General
Engineering
Guideline

ATTACHMENT D General Visual Examination Checklist

IP2-GEG-3113
Rev. 1
Rev. Date: 03-10-2000

ATTACHMENT D (cont.)
Responsible Engineer's Review

00030801.jpg

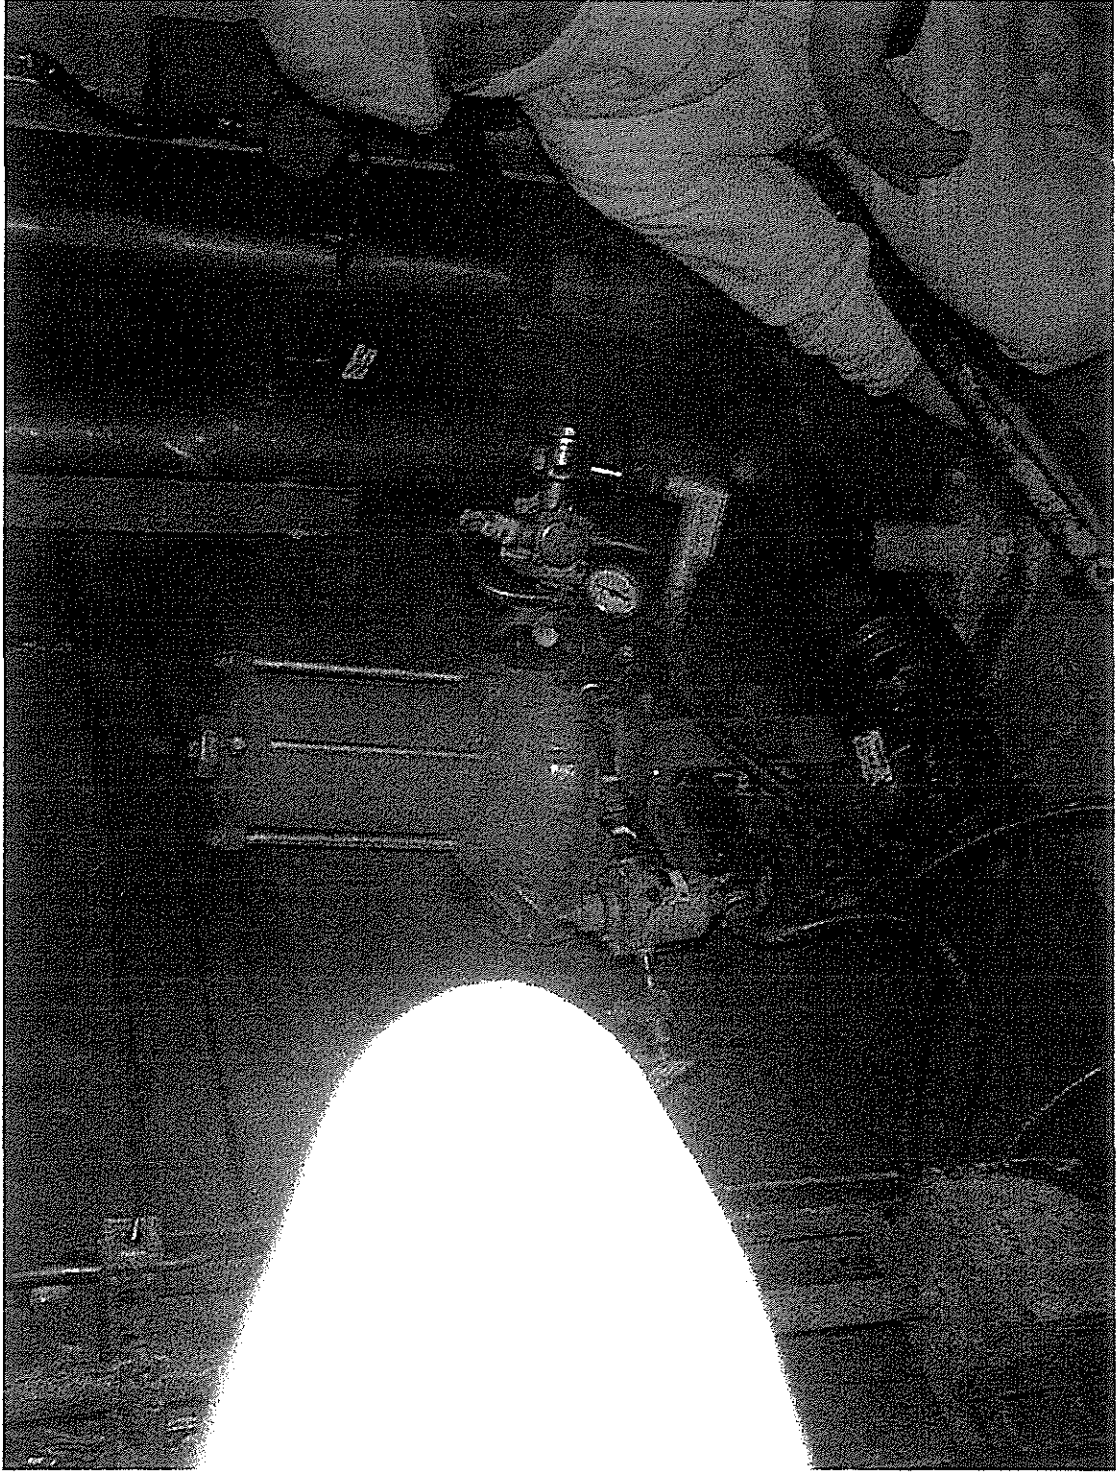
Item No.	Description	Photo
01	Sealant is missing from Column 1-4. See Drawing IWE-DET-001 and ConEd Drawing DMD 322097 Det. 1.	00030801.jpg and 00030804.jpg
02	Metal corrosion is noted below concrete in a 2 foot circumferential area between Column 3-4.	00030905.jpg 00031403.jpg

Item No.	Discussion	Acceptable	Additional Eval. Req'd.
01, 02	The corrosion of the liner at the slab interface requires engineering evaluation to determine its significance relative to Containment integrity. Subsequent investigations have revealed that this condition potentially exists throughout the entire circumference of the containment. The liner corrosion and the moisture barrier have been addressed via CRS 200001209.		✓

00031601.jpg

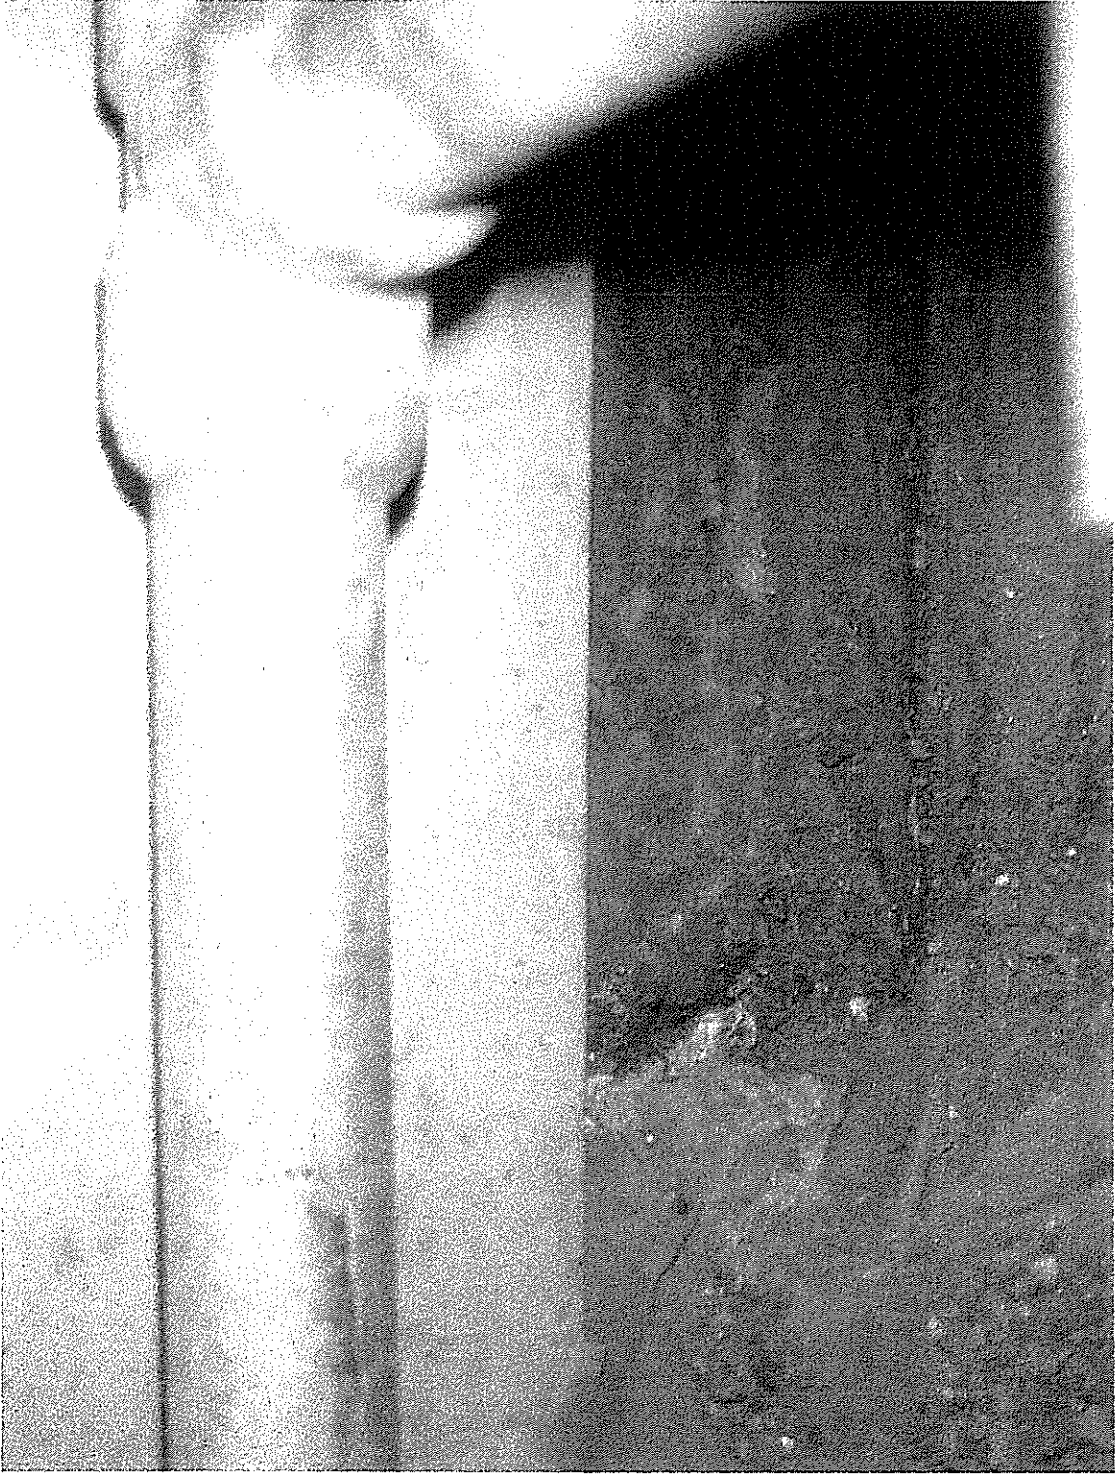
Item No.	Description	Photo
01	Area at moisture barrier caulking sealant is missing from Column 4-5. See Drawing IWE-DET-001 and ConEd drawing DMD 322097 Det. 1. Supplemental examinations will be performed to determine the extent of potential liner degradation.	00031601.jpg and 00031604.jpg

Item No.	Discussion	Acceptable	Additional Eval. Req'd.
01	The corrosion of the liner at the slab interface requires engineering evaluation to determine its significance relative to Containment integrity. Subsequent investigations have revealed that this condition potentially exists throughout the entire circumference of the containment. The liner corrosion and the moisture barrier have been addressed via CRS 200001209.		✓

MP-C

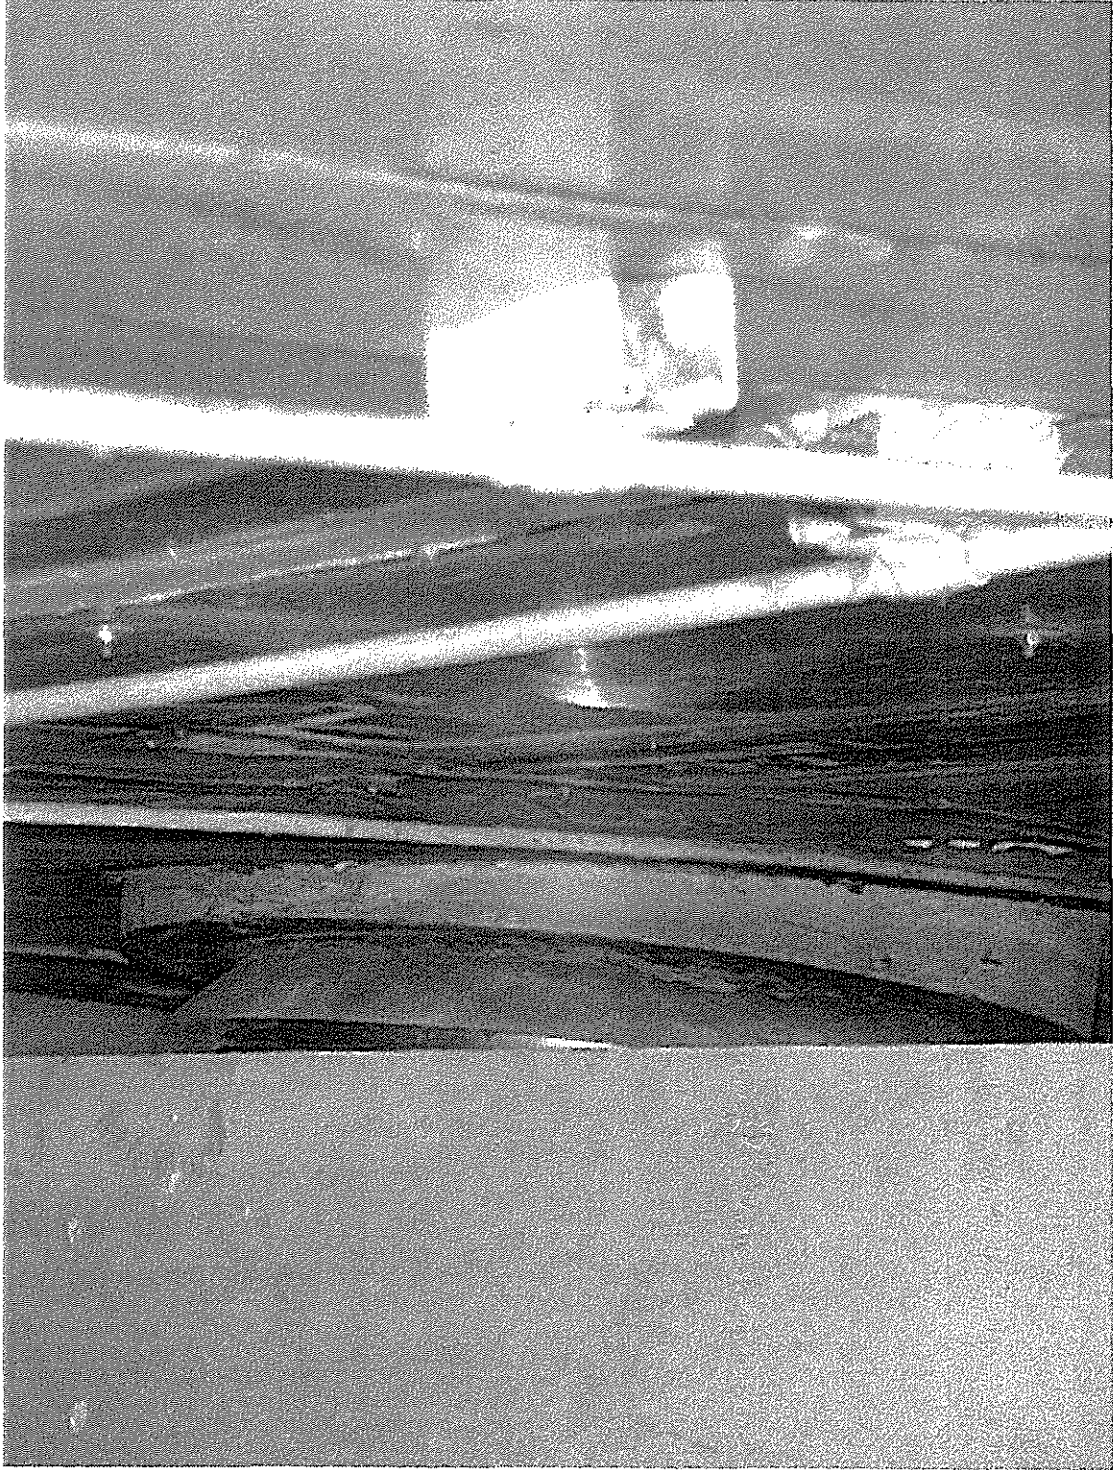
Item No.	Description	Photo
01	Mechanical penetration nos. MP-C, MP-D, MP-G and MP-H showed surface rusting on the head plates. Penetrations are for main steam and feedwater piping with service that will not promote an active corrosive environment. Rust staining around the mechanical penetrations is classified as ASTM D610, Grade 1 -2 that is between 1/3 and 1/2 of the head plate circumference is rusting.	00031706.jpg, 00031707.jpg, 00031708.jpg, 00031709.jpg and 00031710.jpg

Item No.	Discussion	Acceptable	Additional Eval. Req'd.
01	<p>The corrosion on the 2-1/2" thick penetration head plates has resulted from high temperatures, which have burned off the coating and allowed corrosion of the plate. (MP-C and MP-D are for Main Steam lines with process temperatures of 556°F. MP-G and MP-H are for Feedwater lines with process temperatures of 427°F.) The corrosion is powdery in form and does not exhibit flaking or pitting which would indicate a more severe condition. During plant operation the piping temperatures will be sufficiently high as to preclude moisture from the head plates and thus the plates will only be subject to corrosion during plant outages. These times are sufficiently short and the corrosion rates sufficiently low as to not result in significant loss of material (i.e., well less than 10% as discussed in IWE-3512.3) Corrosion on the penetration sleeves is general surface corrosion that has not resulted in any significant loss of material. Examination at the next regular inspection period is sufficient to monitor these conditions.</p>	✓

MP-B

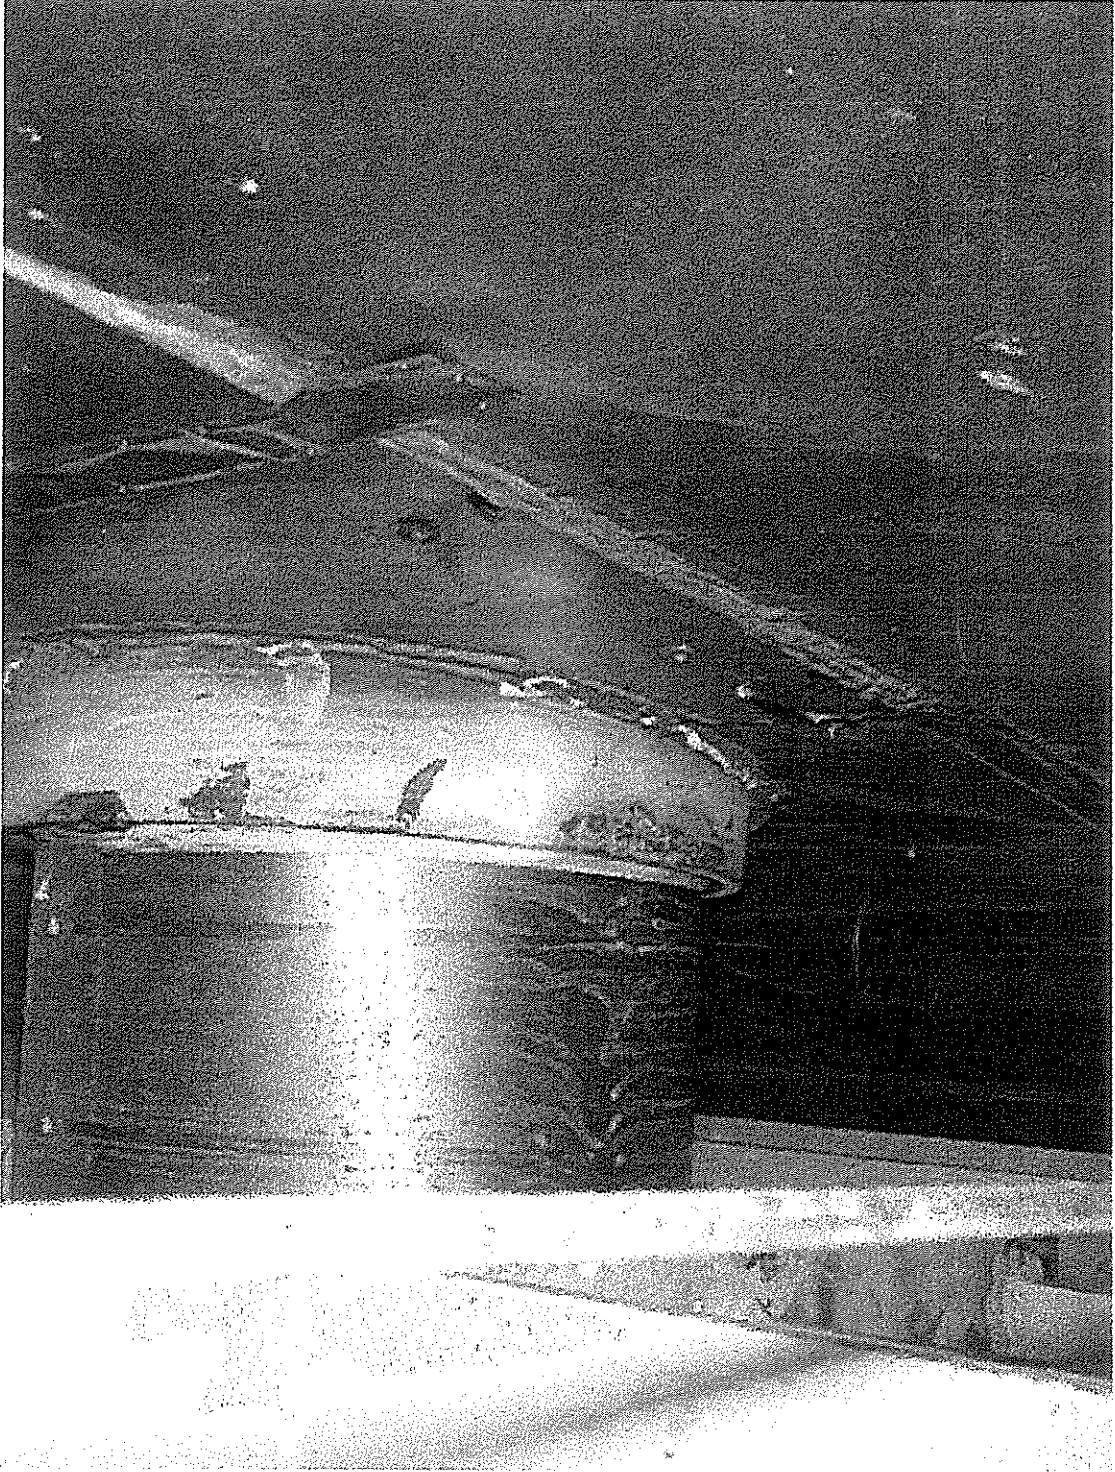
Item No.	Description	Photo
01	Mechanical penetration nos. MP-A, MP-B, MP-E and MP-F showed surface rusting on the end plates. Penetrations are for main steam and feedwater hot piping in which service will not promote an active corrosive environment. Rust staining is classified as ASTM D610, Grade 1-2 (between 1/3 and 1/2 of of end plate is rusted).	00031512.jpg - 00031515.jpg
02	Electrical penetration nos. EP-H11, EP-H12, EP-H13, EP-H14, EP-H15, EP-H16, EP-H17, EP-H18, EP-H58, EP-H59 showed loose surface rusting on the construction primer coat around the weld ring -to-flange areas. Rust staining is classified as ASTM D610, Grade 1-2 (between 1/3 and 1/2 of weld ring-to-flange circumference is rusted).	00031407.jpg - 00031417.jpg
